Memorandum

SUBJECT: Final Supplemental Environmental Impact Report for the Middlefield Park Master Plan Project – Responses to Late Comment Received

Summary of Comments from the Center for Public Environmental Oversight (dated August 30, 2022):

Figure 16 from EPA 2021 Annual Progress Report – Middlefield Ellis – Whisman Fairchild and Regional Groundwater Remediation Programs with the MPMP site boundary:

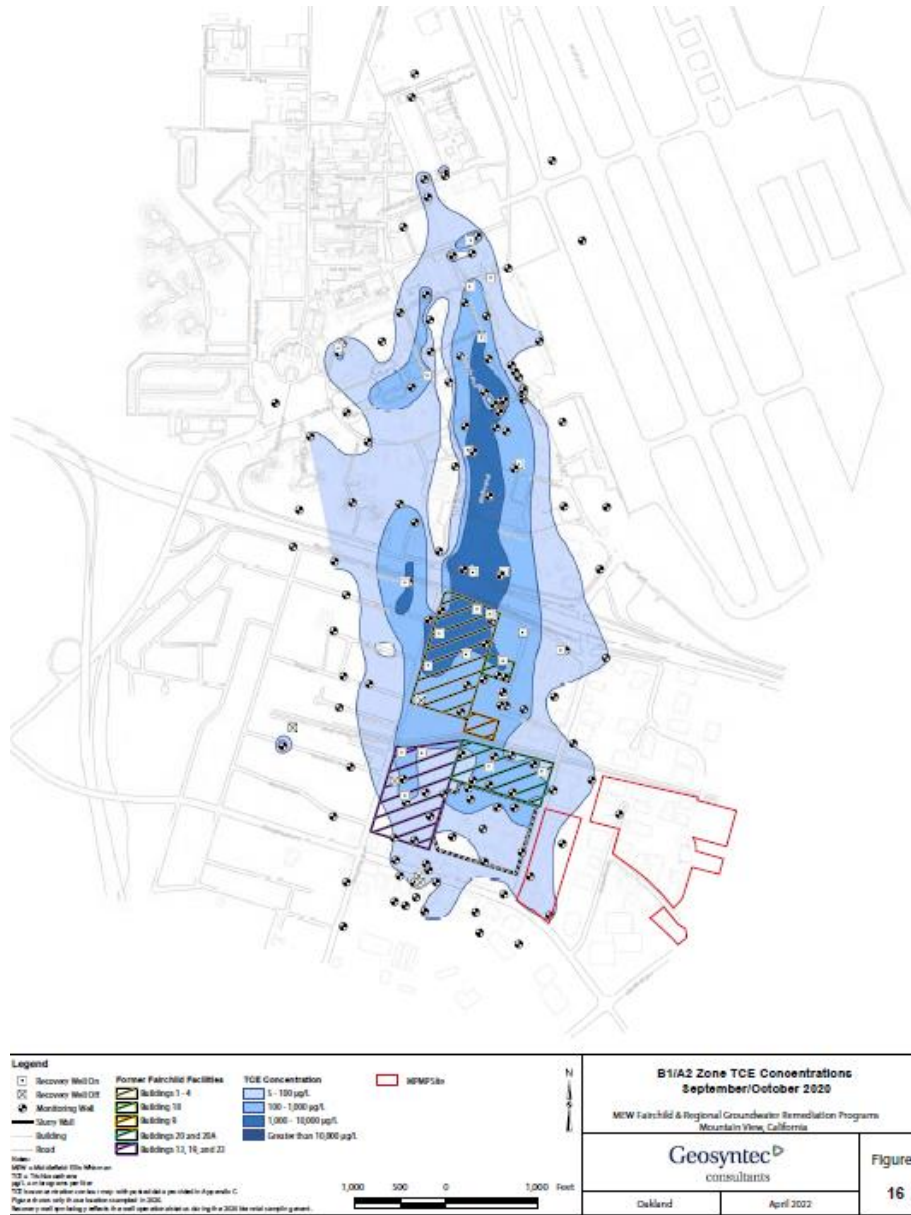
- The draft SEIR states, “Based on recent monitoring data, the MEW plume has encroached into the western edge of the project site.” The Final SEIR should describe and map the encroachment of the MEW plume into the project site.

1. The draft SEIR states, “Based on recent monitoring data, the MEW plume has encroached into the western edge of the project site.” **The Final SEIR should describe and map that encroachment.**

Response 1: *MEW Plume* – Page 131 of the Draft SEIR describes how the MEW plume has encroached into the western edge of the project site. This is detailed in Appendix G of the Draft EIR. EPA regularly monitors and maps the extent of the MEW plume. Because the location of the plume is not static, the most recent map showing the location of the plume is included as Figure 16 in the 2021 Annual Progress Report MEW Fairchild & Regional Groundwater Remediation Progress Report. This Progress Report is available to the public at: <https://semspub.epa.gov/work/09/100027775.pdf>. Additionally, this map has been reproduced and an outline of the proposed project site has been drawn on it to provide further clarity regarding the location of the plume in relation to the proposed project site. A copy of this map is included at the end of this response.
